STATE OF CONNECTICUT
CONNECTICUT SITING COUNCIL

IN RE: :
 :
APPLICATION OF CELLCO PARTNERSHIP : DOCKET NO. 397
D/B/A VERIZON WIRELESS FOR A :
CERTIFICATE OF ENVIRONMENTAL :
COMPATIBILITY AND PUBLIC NEED FOR :
THE CONSTRUCTION, MAINTENANCE AND :
OPERATION OF A TELECOMMUNICATIONS :
FACILITY AT 445 PROSPECT STREET, :
WOODSTOCK, CONNECTICUT : FEBRUARY 24, 2010

RESPONSES OF CELLCO PARTNERSHIP d/b/a VERIZON WIRELESS TO
CONNECTICUT SITING COUNCIL PRE-HEARING INTERROGATORIES

Docket No. 307
 Response to Connecticut Siting Council Interrogatory Question #8
 Existing Verizon Wireless PCS Coverage With Proposed
 Facility at 120 Feet AGL
 Woodstock, Connecticut and Surrounding Area
 (Map Scale is 1:30,000)
 Coverage plot assumes 55% site loading on the Celco system

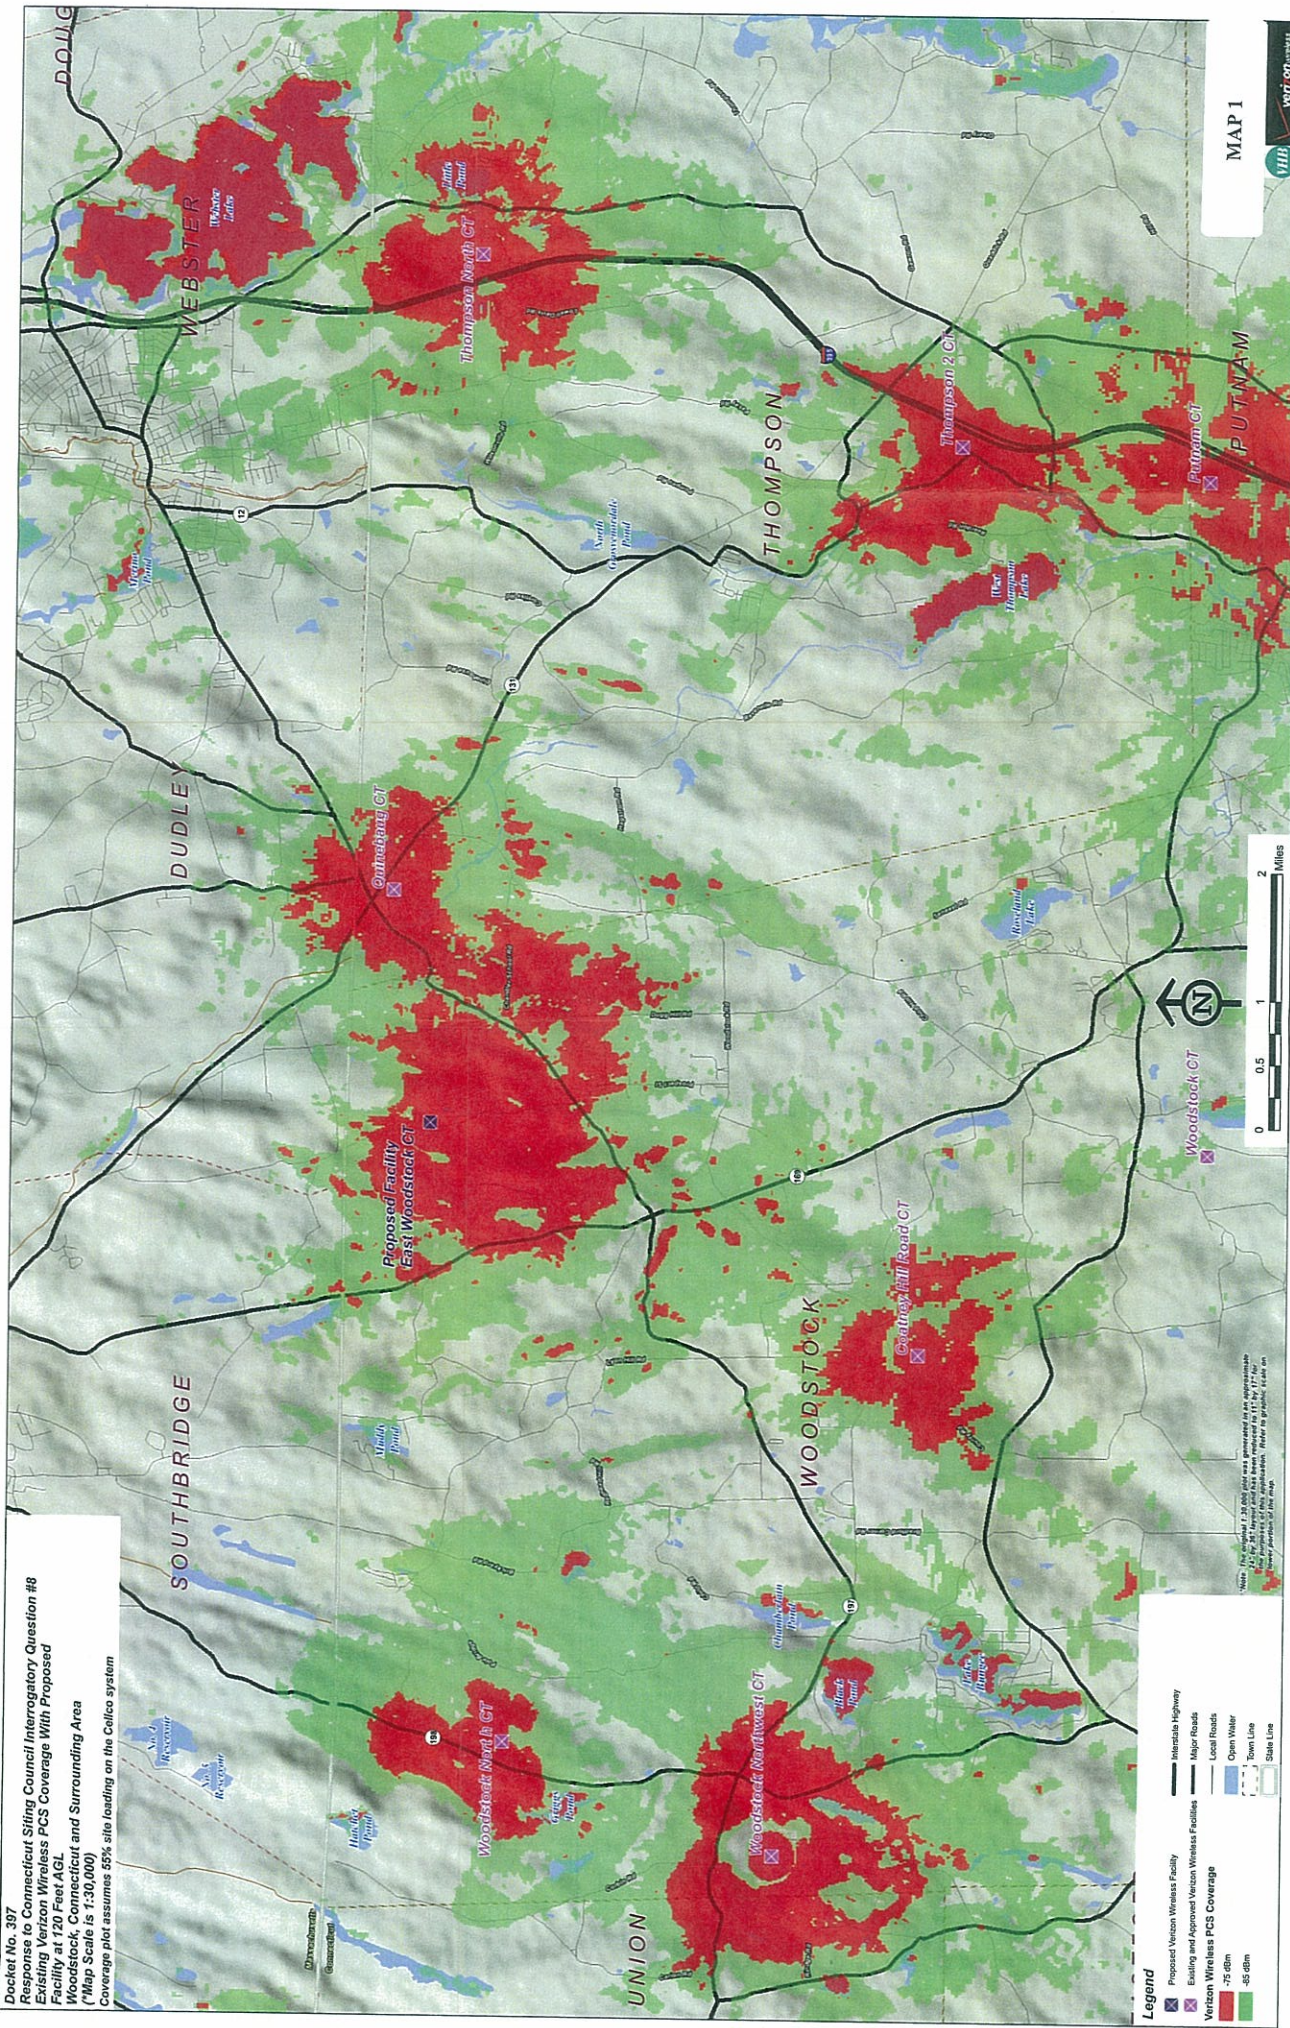
Provide coverage plots (PCS and cellular), using the scale and thresholds in Application Attachment 7, that depicts coverage from existing/approved Cellco sites and the proposed at antenna heights of 120 and 110 feet.

The coverage plots requested are included behind Tab 2. For ease of reference the maps

Map 1 – Existing and Proposed at 120’ – PCS

**Environmental Resources Screen
Proposed Verizon Wireless
Telecommunications Facility
East Woodstock
445 Prospect Street
Woodstock, Connecticut**

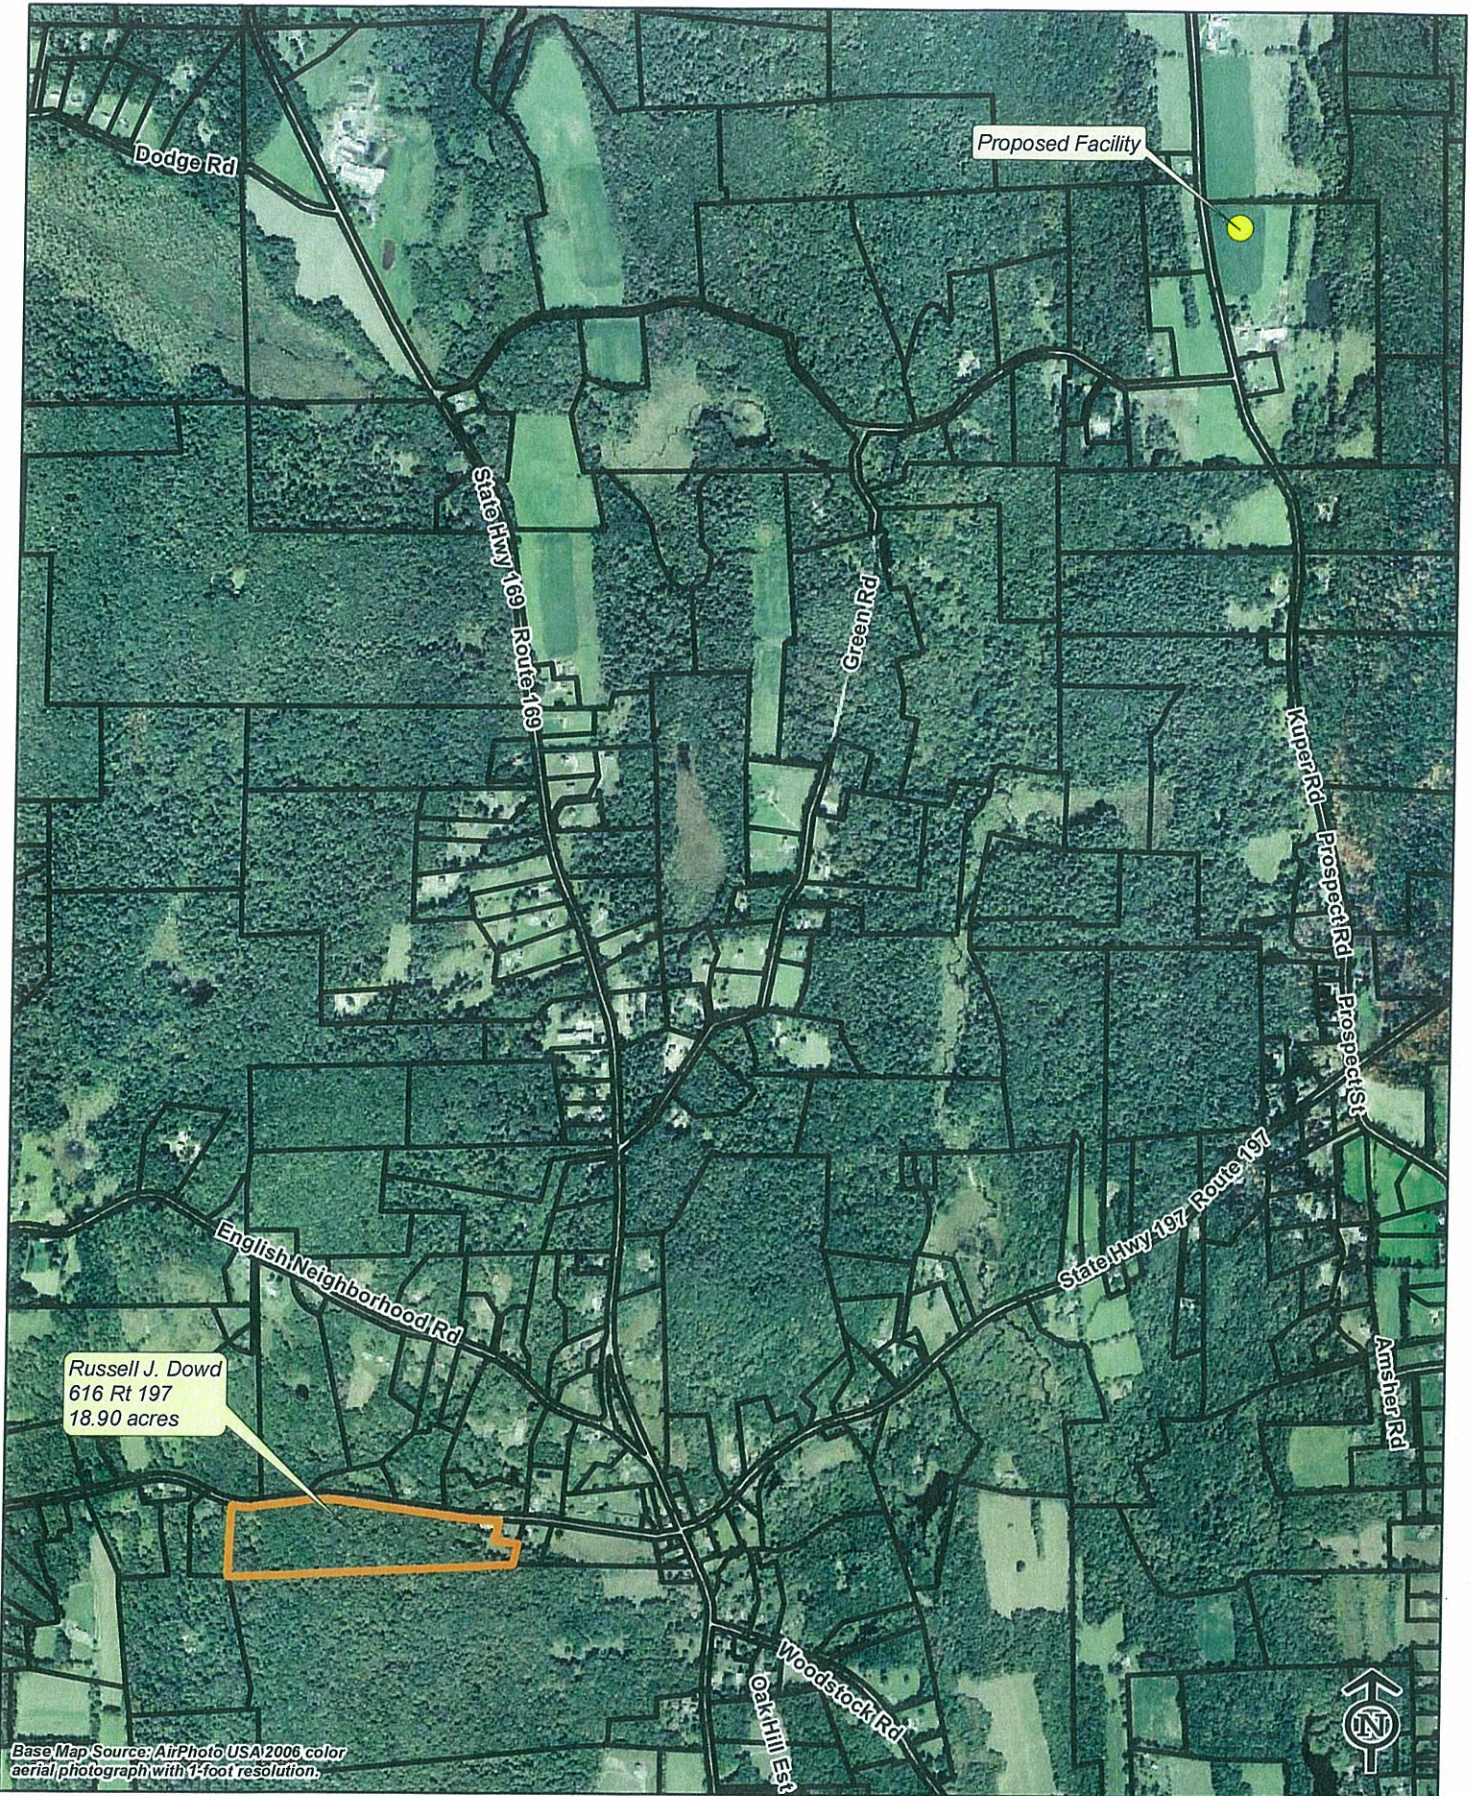
Were other areas of the various Rich parcels considered for a tower site? If so, why was this location selected over the others?

The principle reason for selecting the northwest portion of the 44 acre Rich family parcel is because this area maintains the highest ground elevation on the parcel and would allow for the construction of the shortest tower. As shown on the Environmental Resources Screen map included behind Tab 3, the ground elevation at the Rich property drops off to the south and to the east. For example, Cellco explored a tower site to the south of the proposed location closer to the barn buildings on the Rich property. The ground elevation in this area is approximately 565 feet AMSL, nearly 50 feet lower than the proposed tower location. Cellco would need a tower, taller than 130' at this location to satisfy its coverage objectives. Cellco's landlord would agree to relocate the tower to this area, if the Council asks that it be moved.

As discussed in the Application, a large wetland corridor encompasses the central portion of the Rich property making in the central and eastern portions of the parcel unsuitable for an alternative tower location. The northwestern portion of this wetland corridor was field delineated, as detailed in the Wetlands Delineation Report found behind Attachment 12 of the Application. The full extent of the large wetland corridor is depicted on the Environmental Resources Screen Map.
